FULL-LENGTH DEBONDING OF PRETENSIONED STRANDS

PROPOSED NOTES FOR GENERAL NOTES AND PLAN SHEETS

PROPOSED MODIFICATIONS TO NCDOT *STRUCTURE DESIGN MANUAL*

Where debonded strands are required, indicate the strands to be debonded on the standard drawing, as illustrated in [Figure 6-82](#). Place the following note on the plans:

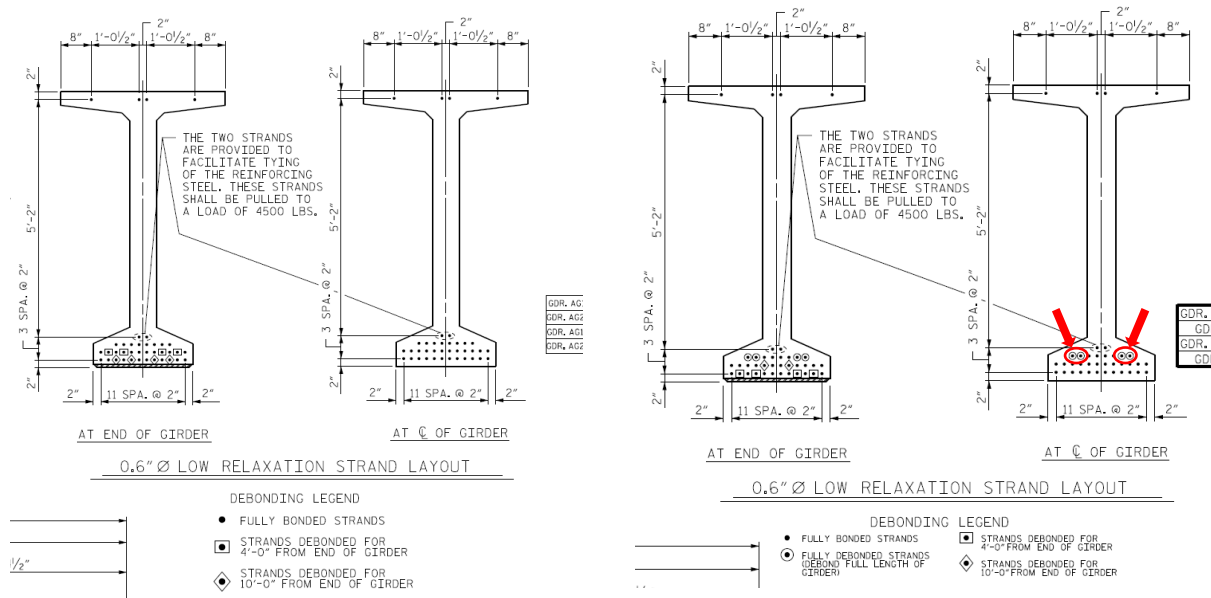
We propose that a note be added to the *Structure Design Manual* after the 3rd paragraph and note for cored slabs in **Section 6.4.1 Design** (repeated below) and for box beams in **Section 6.5.1 Design** with “cored slabs” replaced by “box beams.”

Optional full length debonded strands are shown on the standard drawing to allow cored slabs with different strand patterns to be fabricated in a prestress bed at the same time.
